April 13, 2011

On behalf of Teton County Idaho, we have performed a technical review of the report "Level 1 Nutrient-Pathogen Evaluation for Cattle Creek Ranch" prepared by Intermountain Aquatics and delivered to Harmony Design & Engineering on March 8, 2011. Per Teton County Code Title 9 – Subdivision Ordinance, Appendix A entitled "Nutrient-Pathogen Evaluation Technical Guide for On-Site Wastewater Treatment Systems in Teton County, Idaho"; the following items need to be addressed in order to meet the minimum required elements for a County NP evaluation. Note that many of these items were also requested by the Idaho Department of Environmental Quality in their letter dated February 22, 2011.

**Date:** March 30, 2011  
**To:** William Teuscher – Water Quality Engineer, Idaho Department of Environmental Quality  
**Cc:** Curt Moore, Wendy Danielson – Teton County  
**From:** Eric August, PE  
**RE:** Response to comments received from DEQ and revisions to NP Study for Cattle Creek Ranch

# LEVEL I NUTRIENT-PATHOGEN EVALUATION

Figure 7. Surface Water Setback

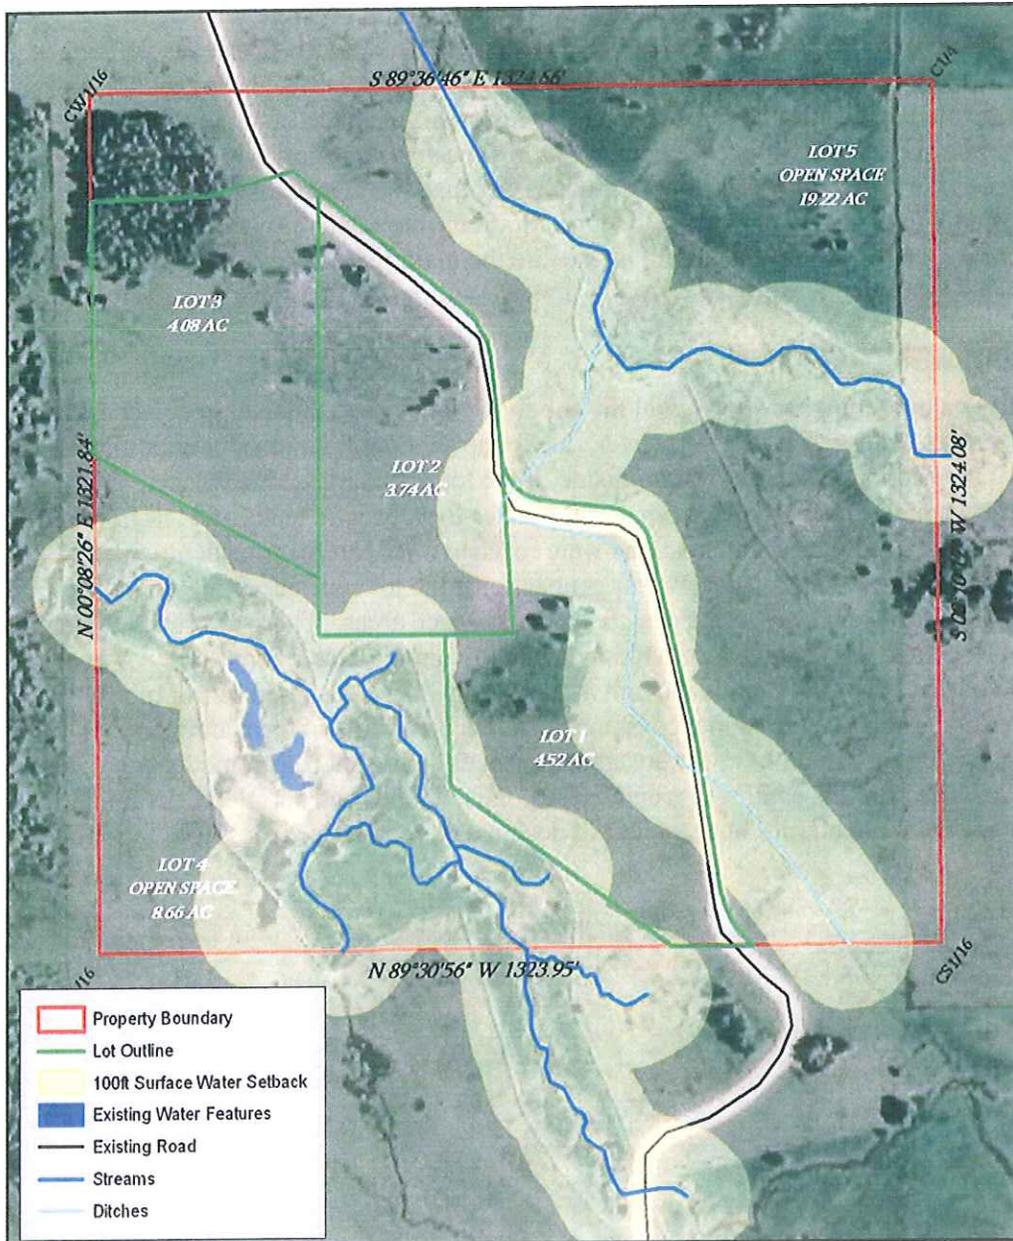
1. Compliance Boundary: Due to the hydraulic connection between impacted groundwater and surface water on the site, phosphorous and nitrate transport should be evaluated using the surface water bodies on the property as the compliance boundary. Discuss the impact of the project on TMDLs in the Teton River.

2. Map: Please provide a map that shows the project with proposed lot configuration, property lines, on-site wastewater treatment systems, water supply wells, surface water features, and the location of surrounding wells within 500 feet of the property boundaries. We also recommend including required setbacks from surface water and wells on the map.

4. Along with criteria listed in the Technical Guidance Manual (TGM), Michael Dronen was consulted regarding placement of drain fields and wells on the three proposed lots. The placement of these features was guided by the need to protect surface waters and comments received by DEQ. All wells and drain fields were placed entirely outside of 100-ft setbacks from surface water (see Figure 9). Both primary and secondary drain field locations are shown in this figure. Every effort was made to locate the drain fields in a staggered pattern relative to the direction of groundwater flow. This was done to minimize the chances of plumes from individual drain fields merging and concentrating the potential water quality impacts. Wells are separated from drain fields by a minimum of 100-ft based on TGM guidance and soils classified as Design Group C.
